Reference: #12S9018500

29 March 2016

**RE: REDEVELOPMENT OF THE IMAX THEATRE AND SURROUNDING PUBLIC DOMAIN UPGRADES DARLING HARBOUR (SSD 7388)**

This letter is provided in response to matters raised by Transport for NSW (TfNSW) in their letter dated 8 March following review of the Transport Impact Assessment prepared by GTA Consultants as part of the above development application.

Figure 1: Sydney City Centre Access Strategy – Proposed and Retained Taxi Ranks

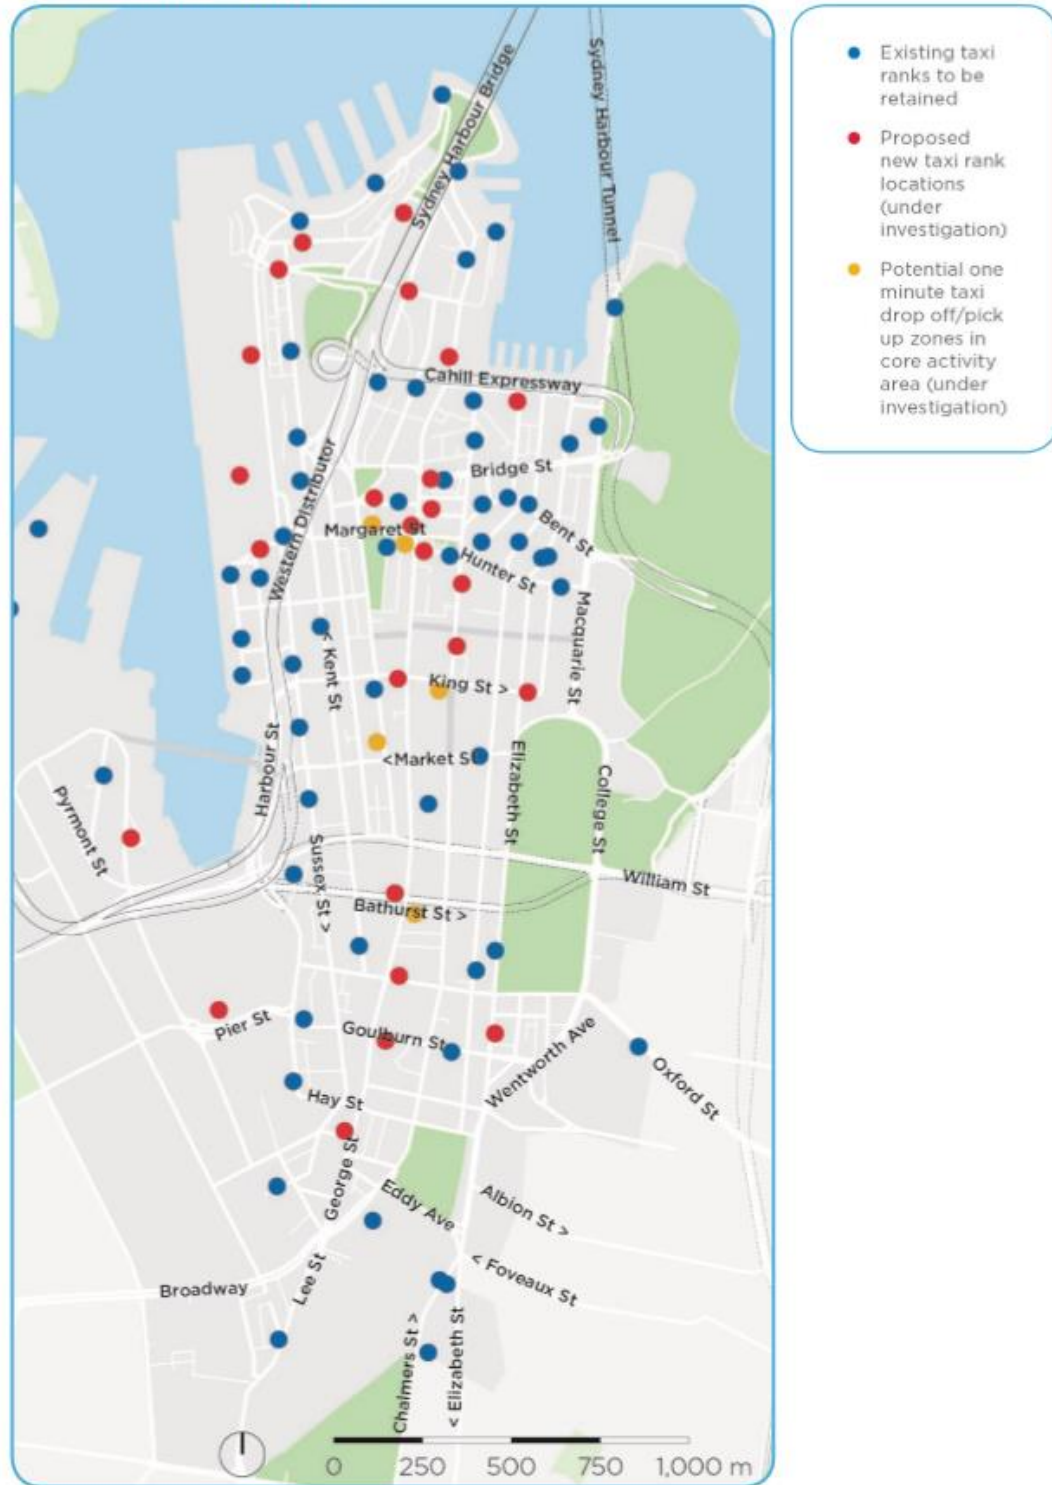
*TfNSW requests that information in relation to taxi ranks, in particular the taxi rank in Wheat Road be included in the Section 2.4 of the Transport Impact Assessment.*

There is currently a taxi zone in Wheat Road to the north of the bus zone, which can accommodate two taxis. The current layout results in manoeuvring issues between a bus and taxi when two taxis are waiting at the taxi zone.

It is noted that the Sydney City Centre Access Strategy does not include the Wheat Road taxi rank as a proposed or retained taxi rank as shown in Figure 1.

Figure 2: Sydney City Centre Access Strategy – Strategic Cycleway Network

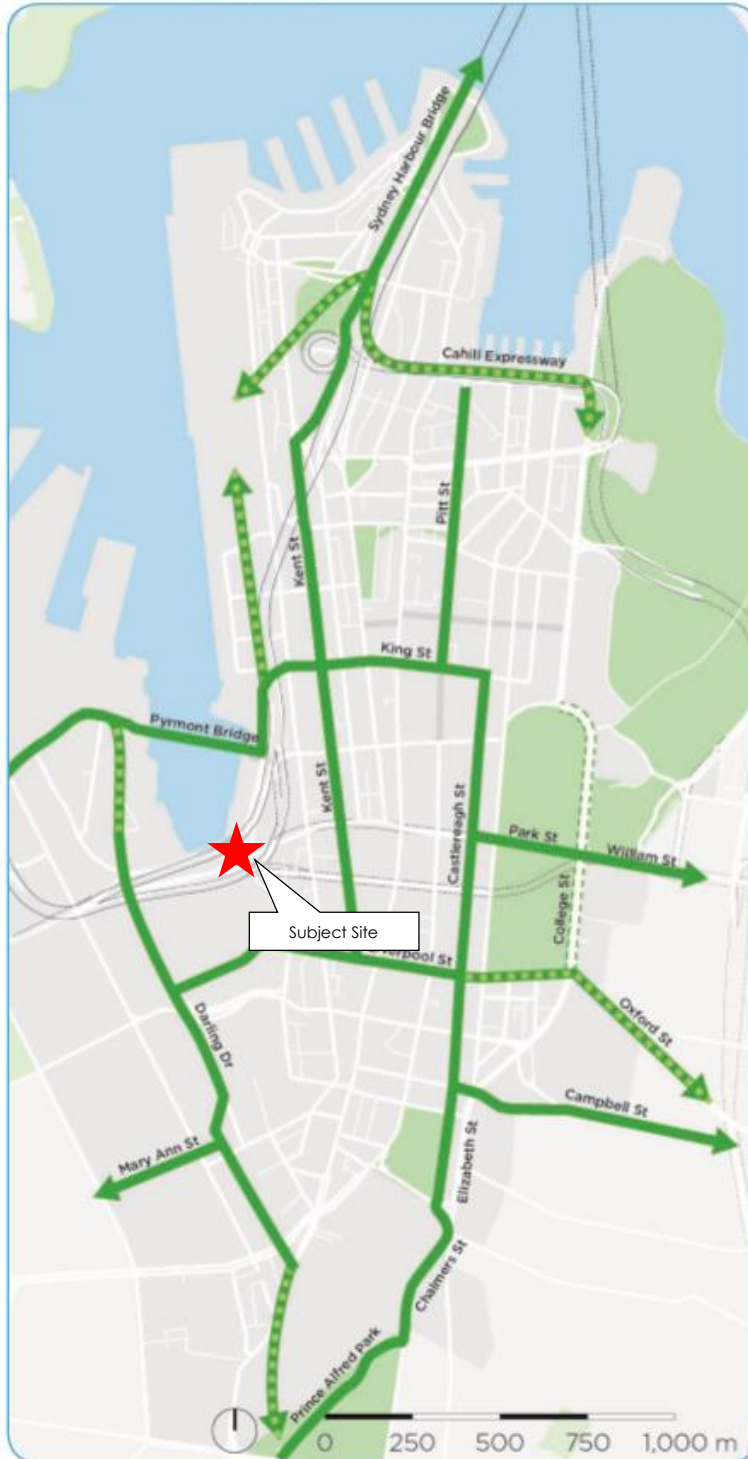
*TfNSW requests that reference be made to the strategic cycleway network identified in the Sydney City Centre Access Strategy in the Section 2.4 of the Transport Impact Assessment.*

The Sydney City Centre Access Strategy provides a strategic cycleway network. As shown in Figure 2, the strategic cycleway network does directly interface with the proposed development site, but would serve to more broadly encourage cycling to/from the Darling Harbour precinct.
